SUBJECT: NexStar™ Hydraulic Cranes with Lower Flow

PART NUMBERS OF AFFECTED PRODUCTS:
HC-12s and HC-12 NexStar Cranes

SERIAL NUMBERS OF AFFECTED PRODUCTS
HC12S-0419-nnnn
HC12-0419-nnnn

Figure 1 – RPH6000 Hoist 123449

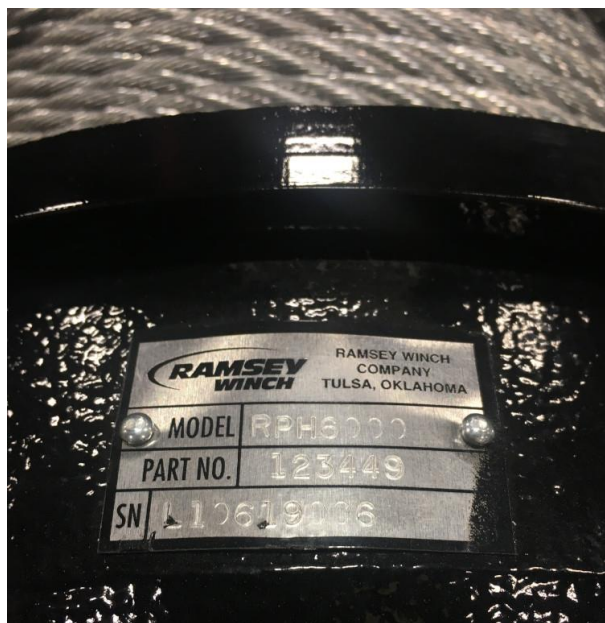
Hoist PN 123435 changed to PN 123449 as shown in Figure 1 – RPH6000 Hoist 123449.

Figure 2 - Motor 458119 Length

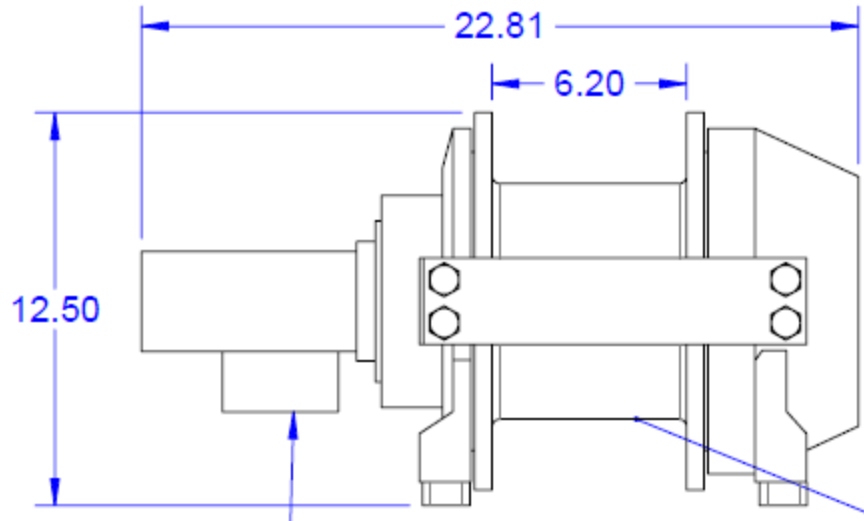
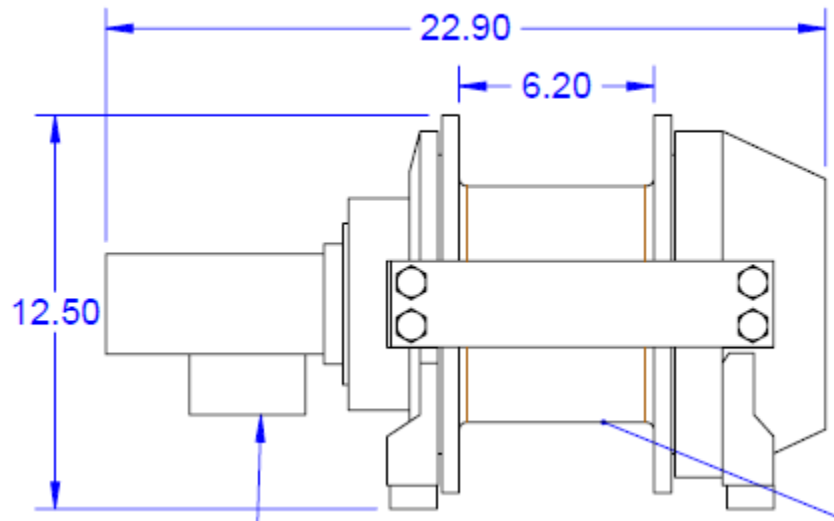
Besides looking at the PN on the hoist tag, the only other way to physically tell the difference in the hoist is to measure the overall length and see that it's a 1/10th inch shorter. The motor itself is what changed in the design and has a 6 - 5/8th in length.

Figure 3 - Higher Flow Hoist 123435 (prior to April 2019)

Figure 4 - Lower Flow Hoist 123449 (April 2019 and newer)

Q: Can I upgrade my higher flow hoist to the new lower flow hoist?

A: Short answer, yes!

Order motor PN 458119 from your nearest Auto Crane dealer which can be located using our website.

Note that the PTO speed or pump will need to change to reduce the overall system flow and heat and reach the necessary 3,000 psi at the crane.
